Record of Decision

Deutsch Relays, Inc.

Site Number 152003

March 1995

FIGURE 4

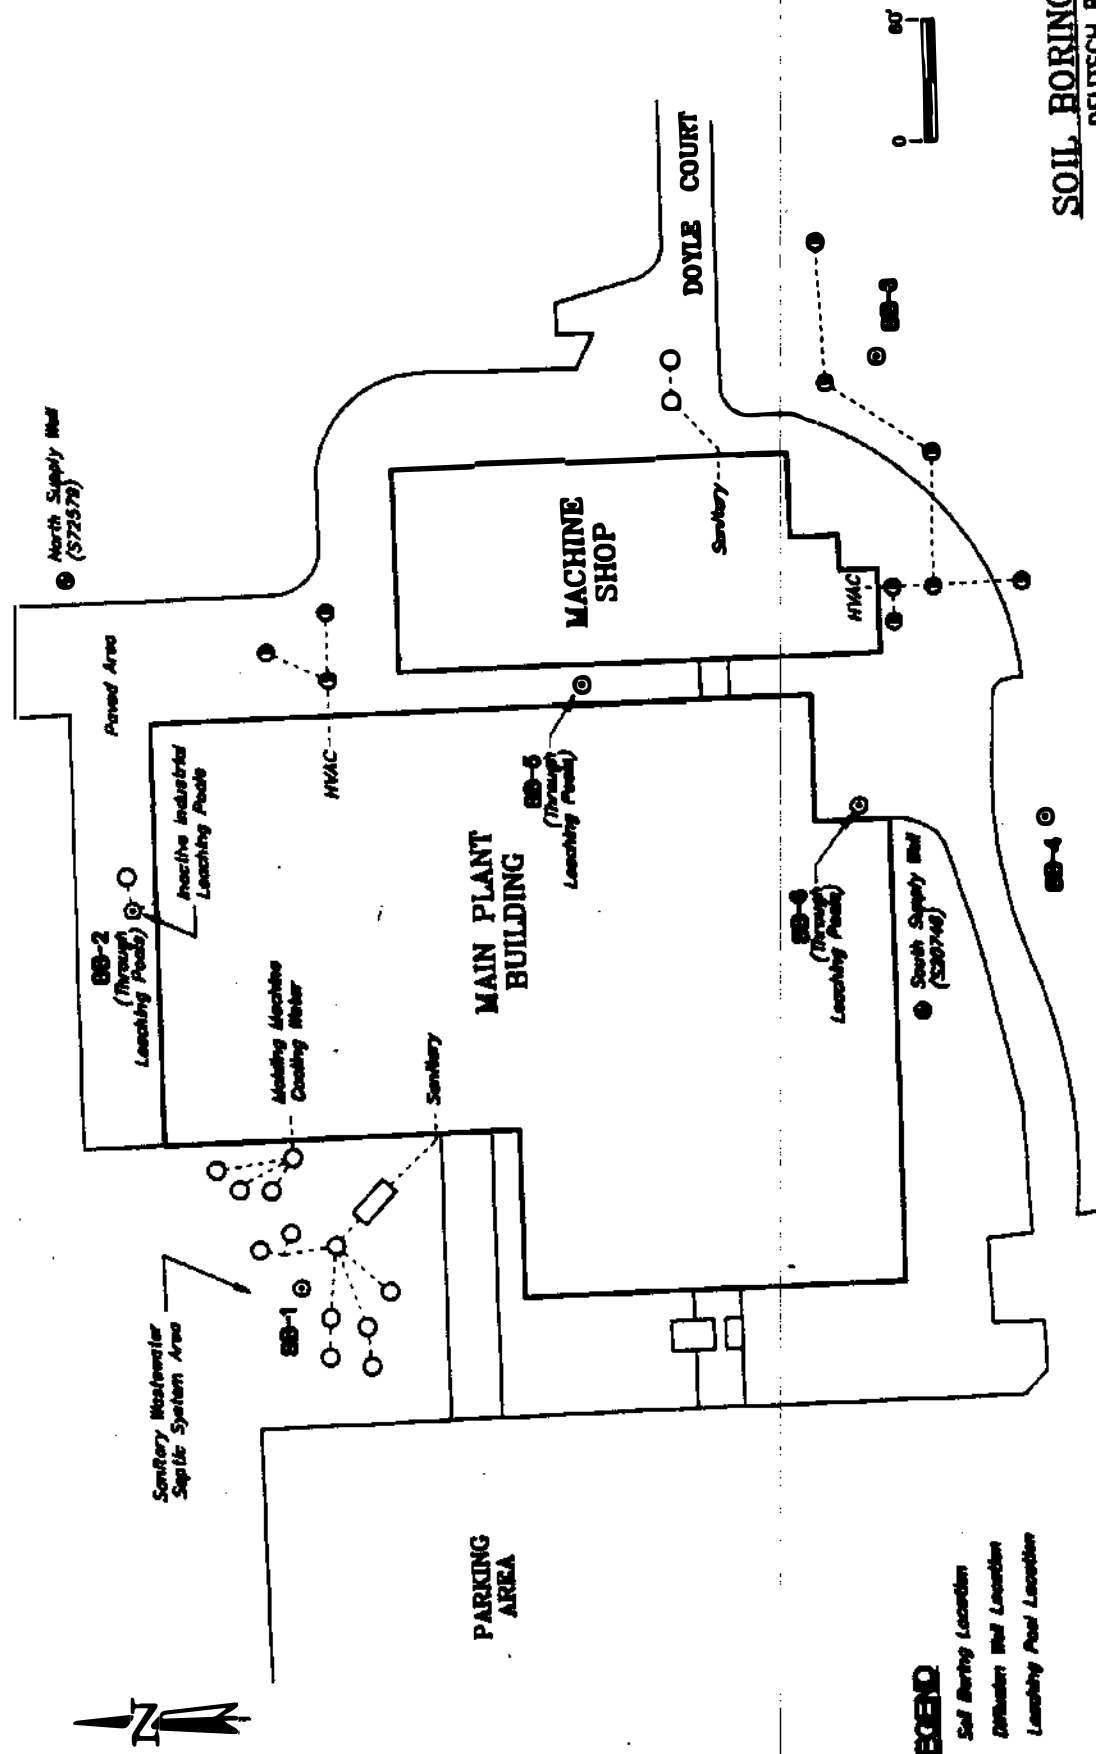
5. **Although it was stated that groundwater on Long Island (past the median line or groundwater divide) flows in a southwest direction, that is not totally accurate. Once again using your Figure 4 as a reference, we see that while it appears that the "hot spot" is moving in a southwesterly direction, the pollution is spreading also in a northeasterly direction - past Larkfield Road, and even as far north as MW-18.**

The contamination detected at MW-18 was below the 5 ppb groundwater standard. Only one VOC was detected, 1,1,1-trichloroethane, which may or may not be associated with the groundwater contamination migrating from the Deutsch site. None the less, this monitoring well will be included in the long-term sampling plan for the site. If VOC levels increase in the monitoring well, steps will be taken to protect public water supply wells downgradient of this location.

FIGURE 11

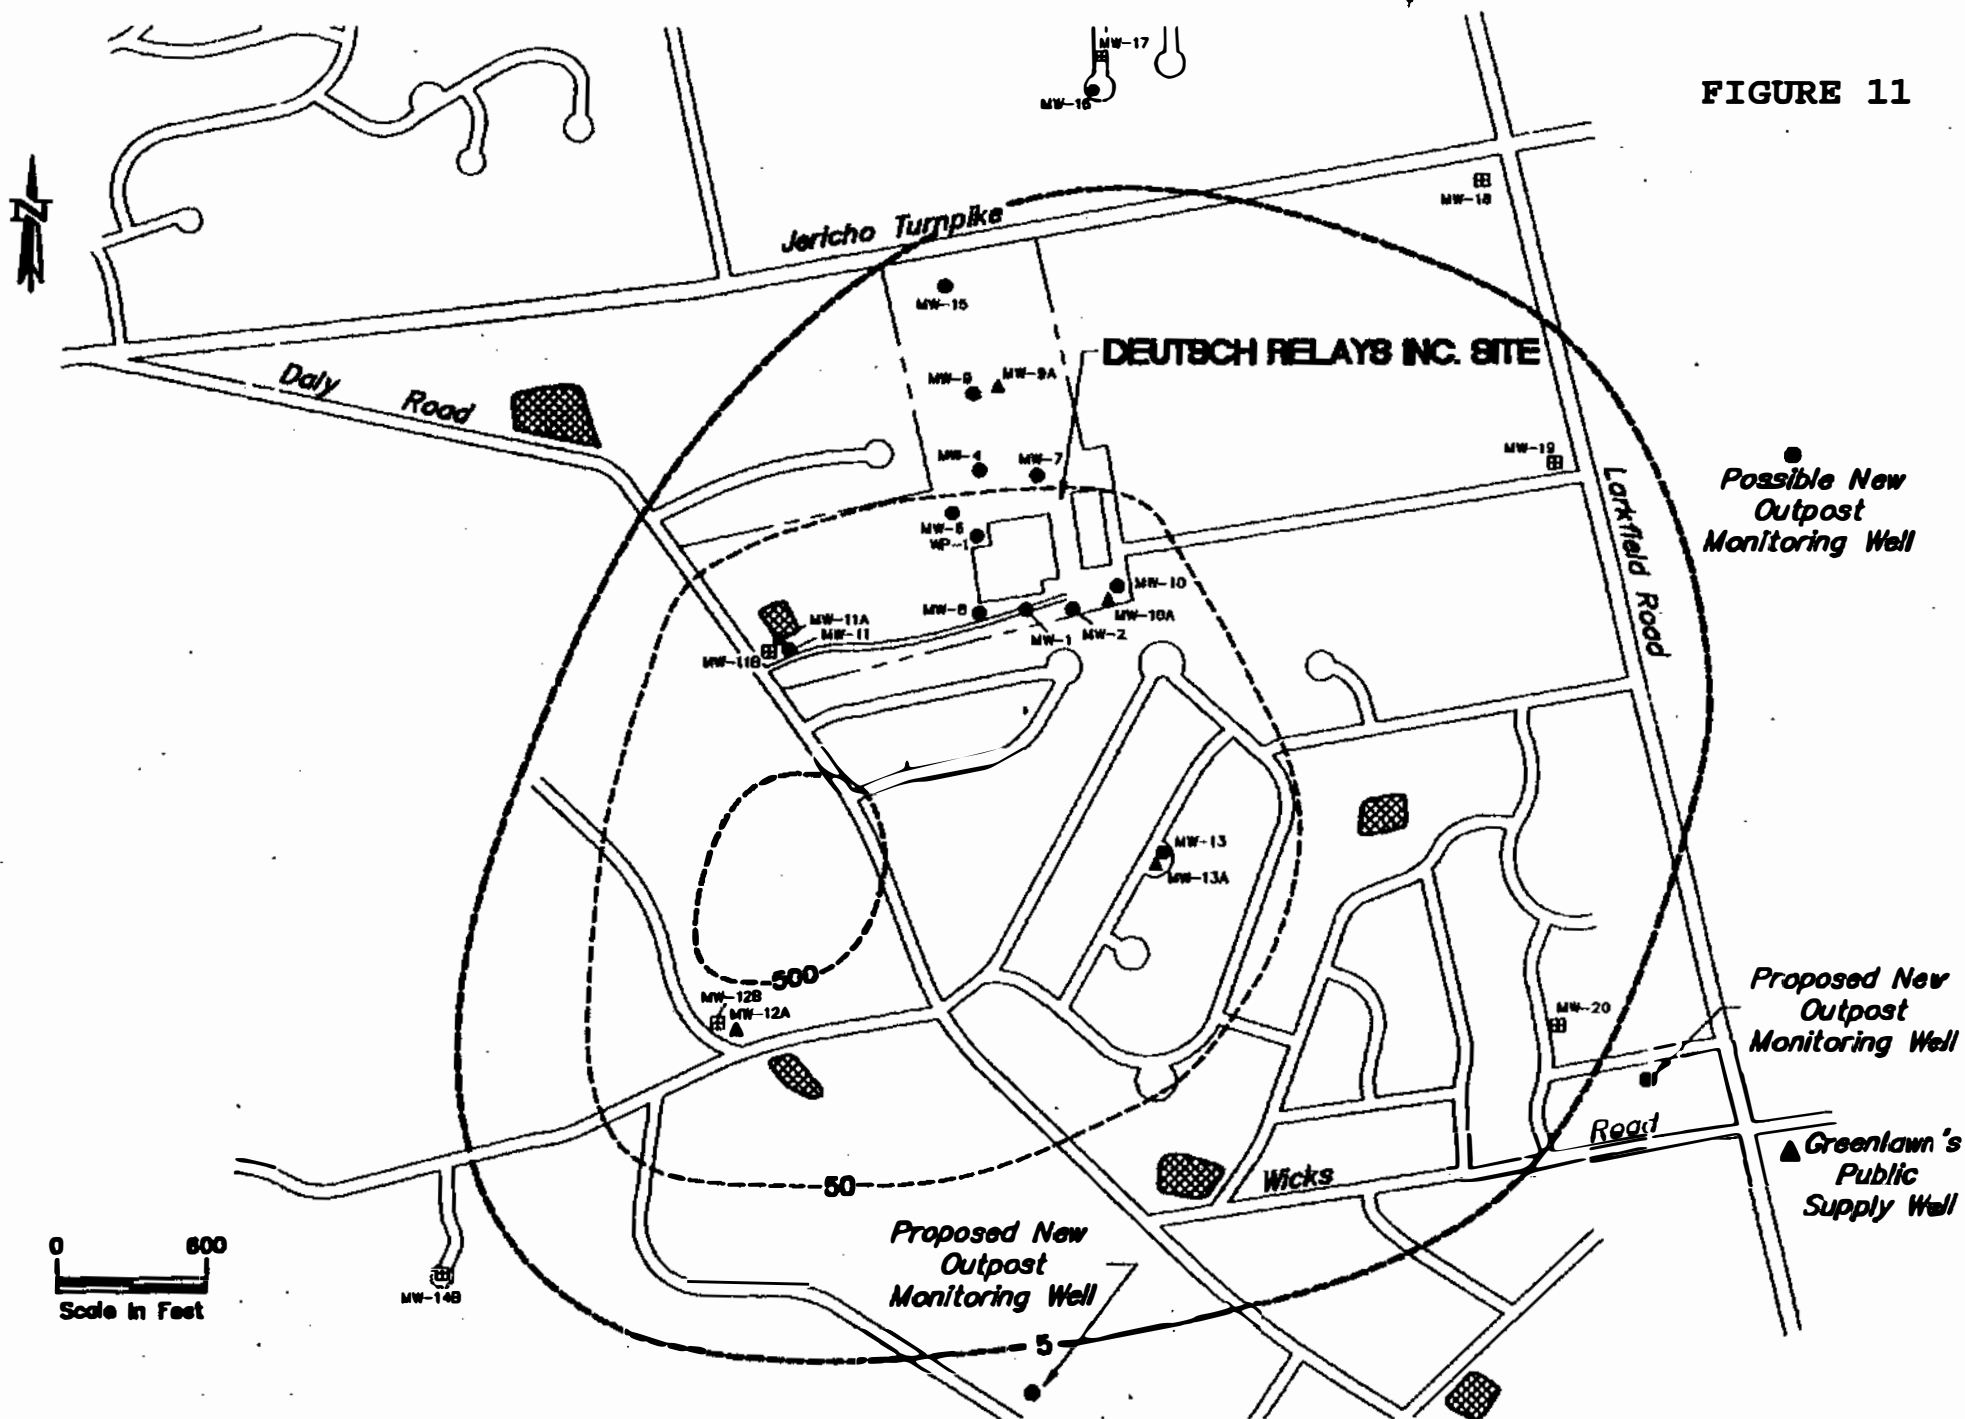
3. **Page 12 should clarify that MW-19 would be the outpost monitoring well upgradient of the Huntsman Lane supply well. MW-19 would be replaced with an outpost well closer to the supply well if the concentrations of individual VOCs at MW-19 exceed 50 ppb (submitted by Eder Associates on behalf of Deutsch AL).**

It is agreed that an additional evaluation will be needed to select appropriate locations for the outpost wells. The Suffolk County Department of Health Services (SCDHS) has requested the inclusion of quantitative groundwater modelling in the remedial design process. It is planned that the SCDHS and the appropriate water district representatives be involved in this selection. Finally, it will serve the interest of the public that these outpost wells or well clusters be installed and sampled as soon as possible, especially the one upgradient of the GWD's Wicks Road public supply wells.
